Document ID: IK0900141

Title: Bus, Durastar & MV Air Compressor Inlet Hose Chaffing / Leaking

Applies To: Bus, Durastar & MV equipped w/Cummins ISB / B6.7

Figure 1: Updated hose PN 6132813C4 & material ID (1BF)

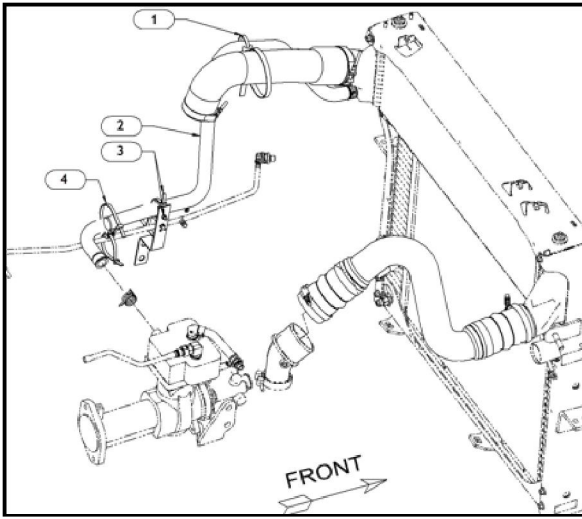
Navistar has identified that, in some circumstances, the Air Compressor Inlet Hose from the Charge Air Cooler (CAC) may chafe or leak during normal vehicle operation. The description and images below offer instructions on how to replace and properly route the new hose assembly.

| Kit Description | Part Number | Quantity | Notes |
|---------------------------------------|-------------|----------|--|
| HOSE, AIR COMPRESSOR, (1BF) (#2 & 2a) | 6132813C4 | 1 | Only required if chafed or leaking Do not use a worm clamp design, this can cut and damage the new hose. |

Figure 1: Top View - CAC pipe saddle & tie strap centered

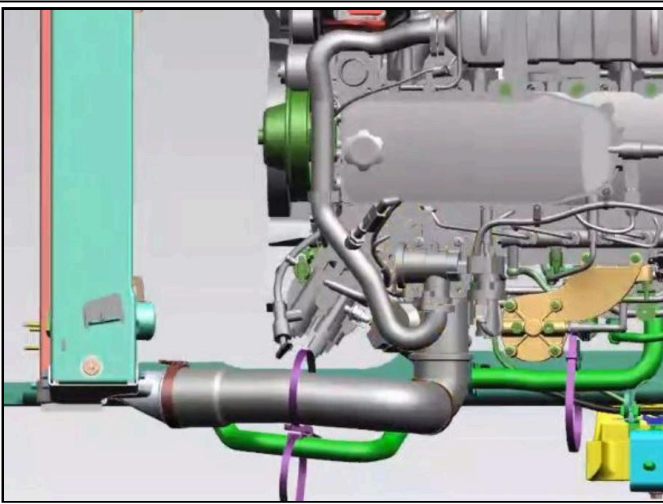
The Air Compressor Intake Hose clipping point on the CAC pipe shall be centered horizontally and securely fastened with the saddle and tie strap.

Figure 2: Side View - CAC pipe saddle & tie strap centered

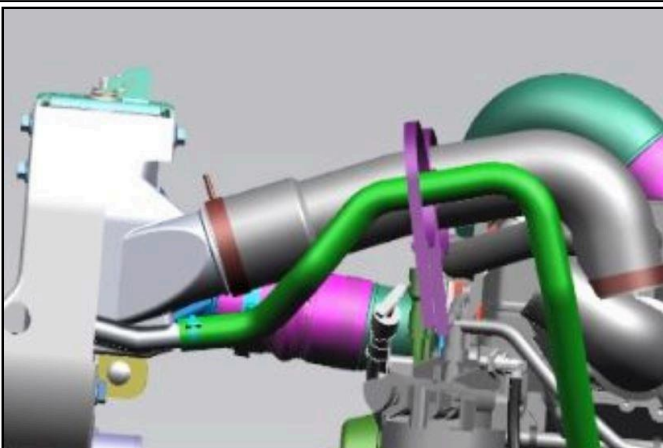
Align the air compressor intake hose with the center of the saddle and tie strap. Pull the zip tie securing it against the

saddle while checking alignment.

Figure 3: Air Compressor Inlet hose routed above fuel line

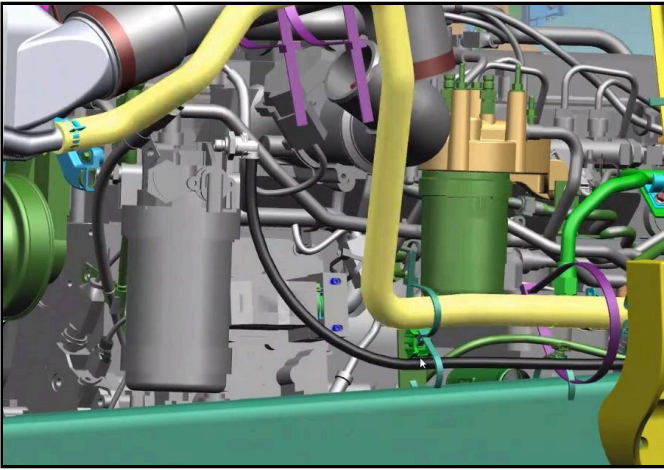
Air Compressor inlet hose routing shall be routed above and parallel to the fuel line, positioned in the highest clipping point in the stanchion bracket, and securely fastened with a tie strap.

Figure 4: Rearward projection - Sharp Edge rotated to away

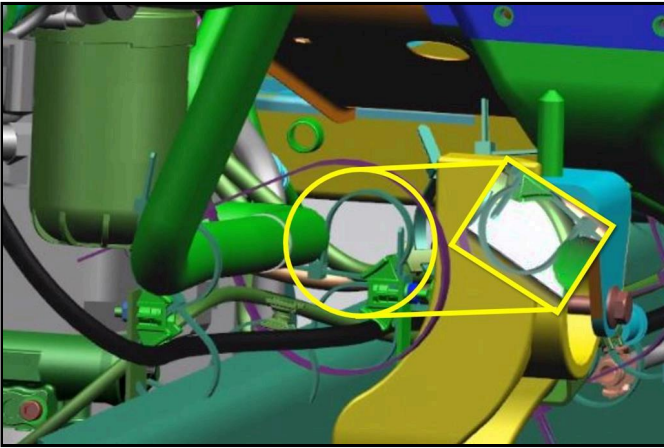
Align the air compressor intake hose with the center of the saddle and tie strap. Pull the zip tie securing it against the saddle while checking alignment. Trim sharp pieces of zip ties away from the hose to prevent damage and further rub point.

Figure 5: Air Compressor End Securement

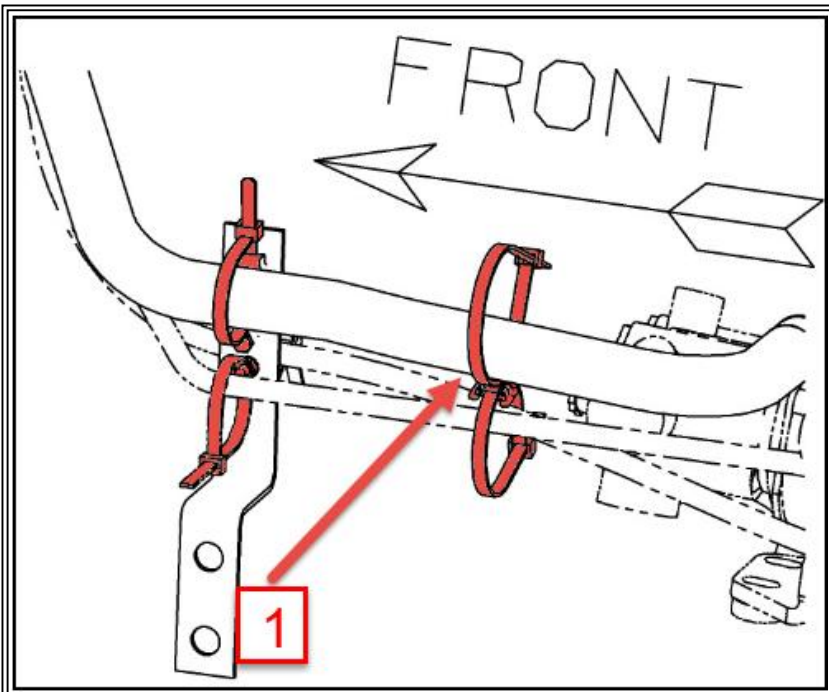
Item 1: Ensure cable lock swivel PN 4077219C1 is installed between cable locks to allow for hose movement.
